**PLANNING DEPARTMENT
CSS DESIGN STUDY REPORT
AMATS SPENARD ROAD REHABILITATION:
MINNESOTA DRIVE TO BENSON BOULEVARD PROJECT
STAFF ANALYSIS**

DATE	April 11, 2022
CASE NUMBER	2022-0031
APPLICANT	State of Alaska Department of Transportation and Public Facilities (DOT&PF)
REPRESENTATIVE	Lounsbury & Associates
REQUEST	Context Sensitive Solutions (CSS) Design Study Report (DSR) Review for Anchorage Metropolitan Area Transportation Solutions (AMATS) Spenard Road Rehabilitation: Minnesota Drive to Benson Boulevard Project
LOCATION	Spenard Road between Minnesota Drive and Benson Boulevard
COMMUNITY COUNCILS	All Community Councils, Spenard
TAX NUMBER	N/A
GRID	SW1629, SW 1729
ATTACHMENTS	<ul style="list-style-type: none"> 1. Application 2. Comments
RECOMMENDATION SUMMARY	Approval with conditions
SITE	<ul style="list-style-type: none"> Area: ±0.6 mile Spenard Road corridor Zoning: B-3 (General Business) Topography: Generally flat
COMPREHENSIVE PLAN	<ul style="list-style-type: none"> <i>Anchorage 2040 Land Use</i> Town Center, Main Street Corridor, Urban <i>Plan Land Use Classifications:</i> Residential – High, Urban Residential – Medium Growth-Supporting Features include Transit-Supportive D

Figure 12: Single Receiving Lane in the Eastbound Direction from Minnesota Drive to 36th Avenue

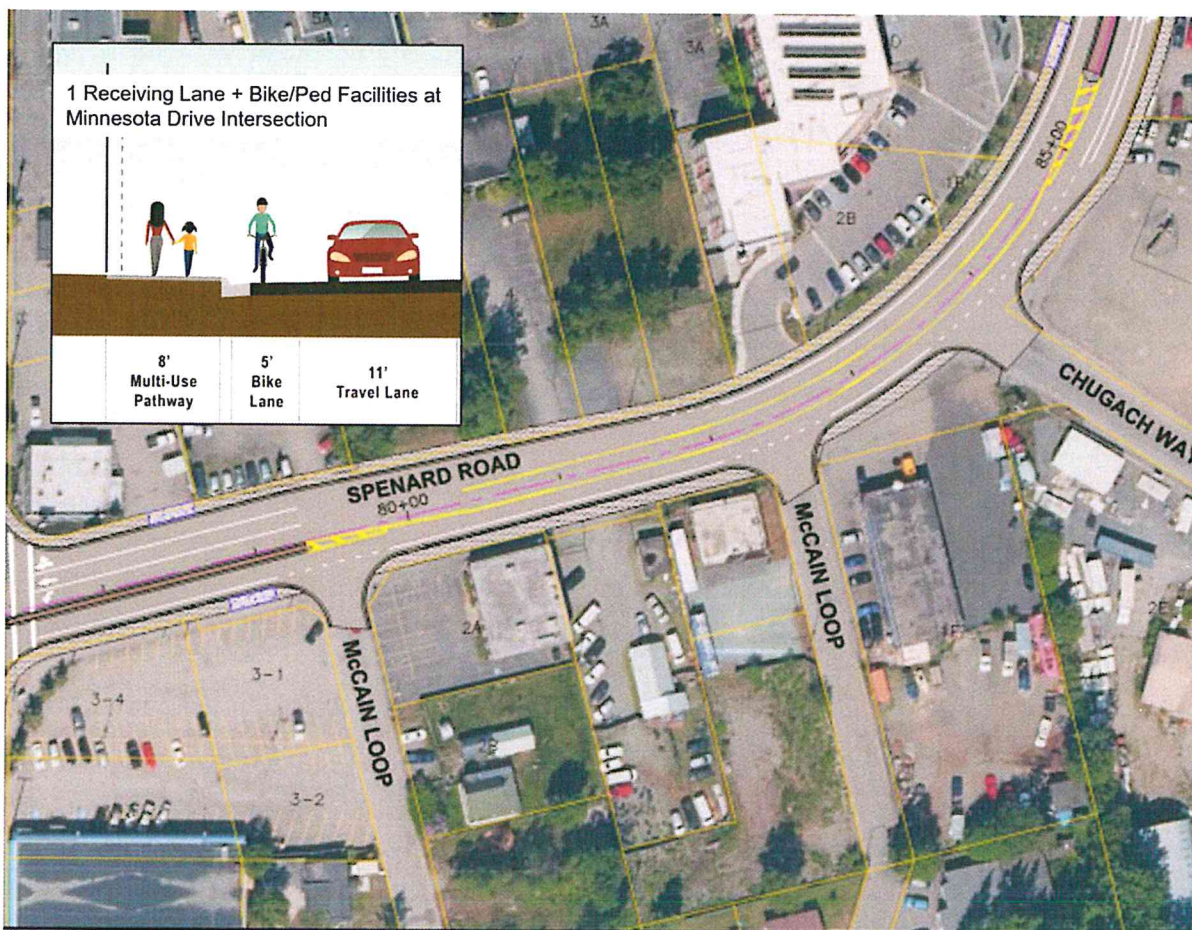
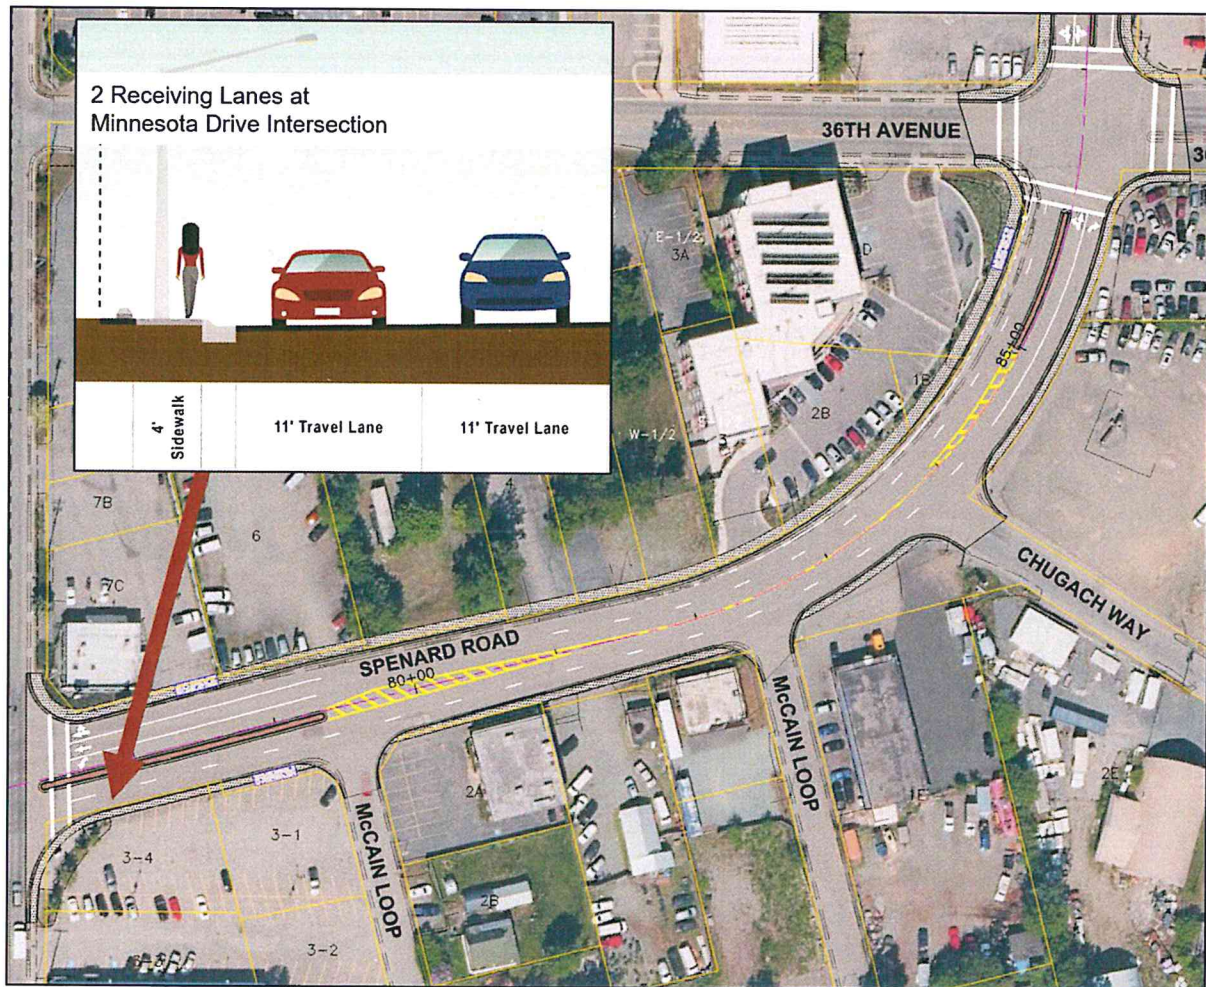
There are two options still undergoing evaluation for the intersection of the project corridor with Minnesota Drive. The first option would have two receiving lanes from Minnesota Drive to 36th Avenue and would not have pedestrian facilities on the south side of the roadway. The second option would provide the pedestrian facilities, but would reduce the receiving lanes from two to one. The second option aligns better with the project and with goals and objectives of municipal plans, but additional evaluation is necessary to review capacity and access impacts.

The *AMATS Non-Motorized Plan* identifies Spenard Road and Minnesota Drive as a high priority for both pedestrian and bicycle corridors. Maintain facilities at the Spenard Road-Minnesota Drive intersection if further study proves it to be feasible.
